**Consultation Paper - Battery energy storage systems offering instantaneous reserve**

1. This is a submission by the Major Electricity Users' Group (MEUG) on the Electricity Authority (EA) consultation paper "Battery energy storage systems offering instantaneous reserve" (BESS offering IR) with appendices A and B published 8<sup>th</sup> April 2021.<sup>1</sup> MEUG members have been consulted in the preparation of this submission. This submission is not confidential. Some members may make separate submissions.

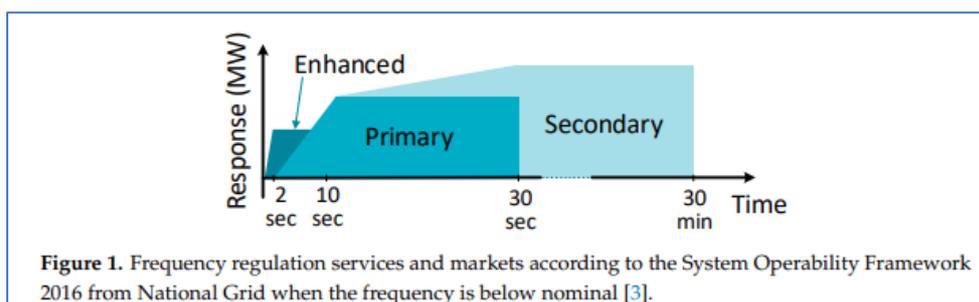
It has been shown that there should be a super-fast reserves market because BESS can respond faster than PLSR and TWDR. Thereby a smaller capacity can halt a frequency drop more effectively. Below is the UK FS market design that allows wind turbines with inverter control to act as Virtual Synchronous Machines (VSM) not just batteries.
